UNITED STATES PATENT AND TRADEMARK OFFICE

Office Action Summary

10/630,915

KUECHLER, GUNTER

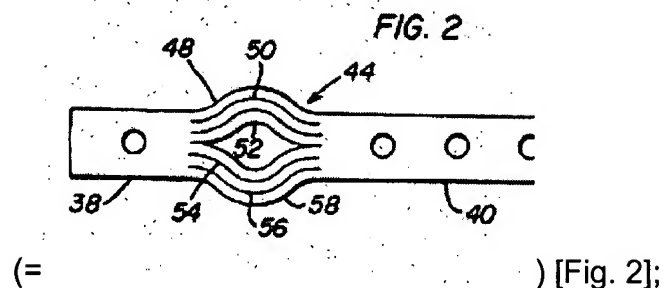
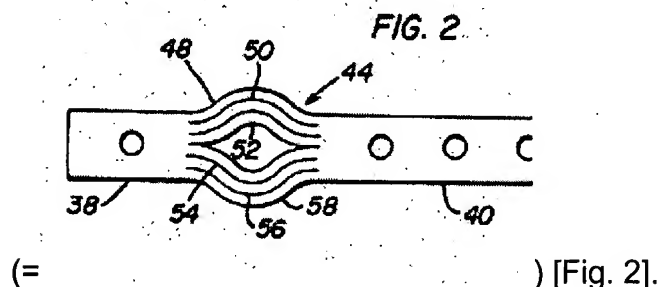
Claims **1 and 17** are rejected under 35 U.S.C. 102(b) as anticipated by or, in the alternative, under 35 U.S.C. 103(a) as obvious over **Webb et al.** (US Patent No. 3,422,213).

Webb teaches a solar cell connector (= an electrically conductive connector strip) [col. 1, lines 13-21] comprising:

(a) a metallic strip (= an elongated strip formed from beryllium-copper or other suitable metals, such as nickel, copper-tin-phosphorous, nickel-silver, and copper) [col. 3, line 53; and col. 4, lines 56-61];

(b) first **38** (= a first section) and second **40** (= a second section) connection areas formed in said metallic strip, said connection areas comprising tabs for connection to respective solar cells (= the connectors thus permit the coupling of a larger group of electrical devices such as solar cells) [col. 4, lines 62-67; and Fig. 2]; and

(c) a centrally situated compensation section **44** (= a stress relieved area) formed in said metallic strip integrally with and intermediate said connection areas (= providing a connector of the flat strip type which includes a stress relieved area in the form of a plurality of integral strand-like portions) [col. 2, lines 26-47; and Fig. 2];

wherein, the compensation section comprises a single central opening in said metallic strip (= the single central opening parted by the strands **48, 50, 52, 54, 56, 58**) [Fig. 2]; and

said central opening is intermediate said first **38** and second **40** connection areas, and is delimited by a surrounding marginal area of said metallic strip, which marginal area is one of band-shaped round, **oval**, angular and polygonal

whereby said first 38 and second 40 connection areas and said compensation section 44 comprise a unitary continuous segment of said metallic strip

The solar cell connector is produced by stamping, etching or eroding (= by chemical milling) [col. 2, lines 31-35; col. 3, lines 6-9; and col. 4, lines 54-56].
